**49 CFR Parts 216 and 238
Passenger Equipment Safety Standards;
Final Rule**

Passenger Equipment Safety Standards

ACTION: Final rule; response to petitions for reconsideration.

SUMMARY: This document responds to certain of the petitions for reconsideration of FRA's May 12, 1999 final rule establishing comprehensive Federal safety standards for railroad passenger equipment. This document clarifies and amends the final rule.

Figure 2

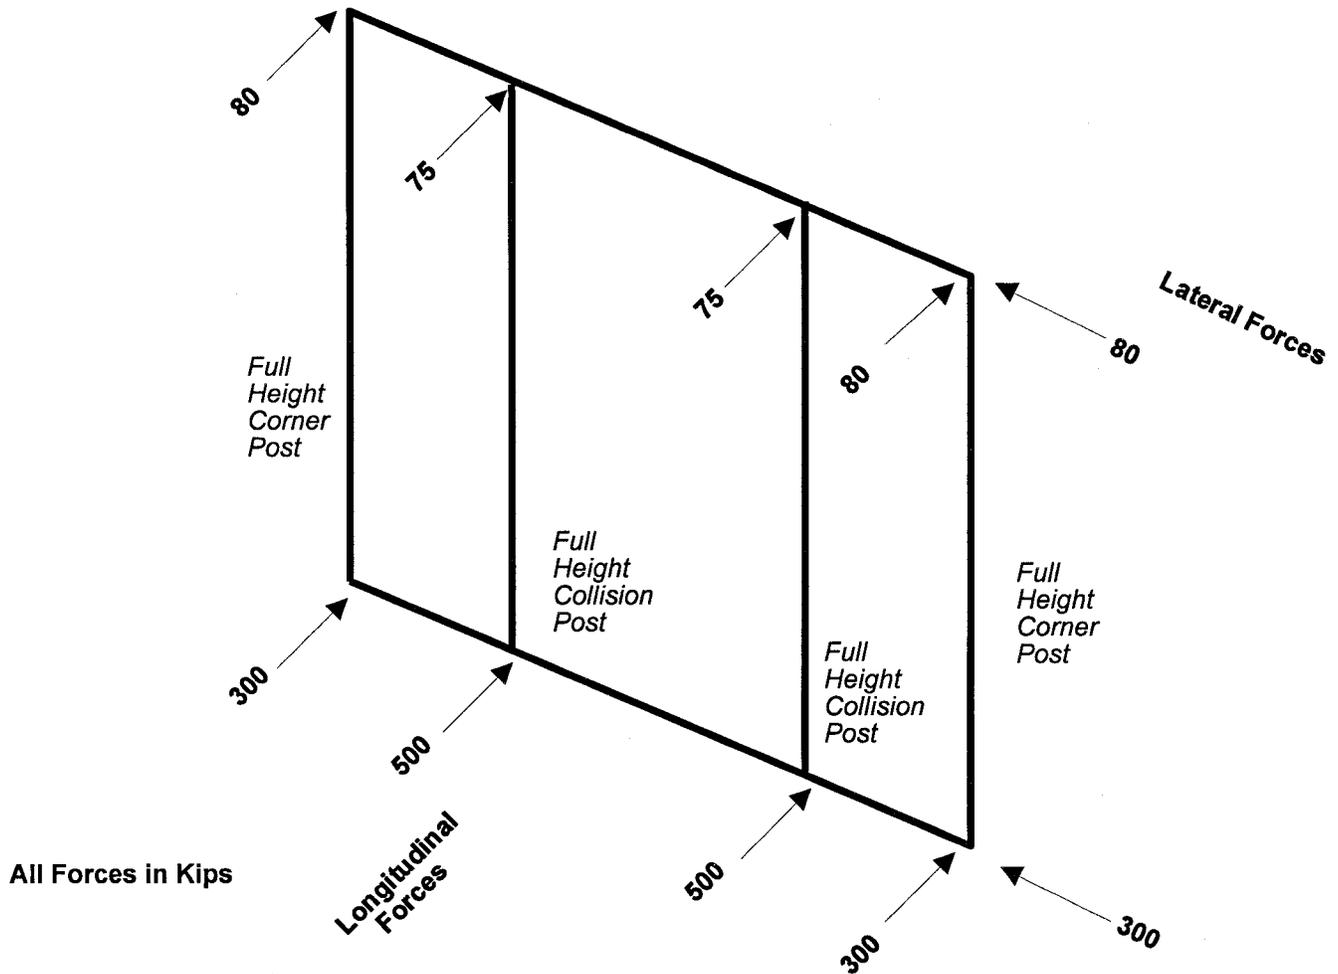
FRA has adopted Bombardier's request and modified paragraph (b)(1) accordingly. (FRA has also made a

corresponding change to figure 2 to subpart E.) FRA recognizes that the strength of the power car cab's rear collision posts should not necessarily be dependent on the strength of the cab's front end structure, as the front and rear end structures are intended to protect against somewhat different hazards. The front end structure must protect against the greater hazard of a head-on collision with another train or object.

30. Figure 2 to subpart E is revised to read as follows:
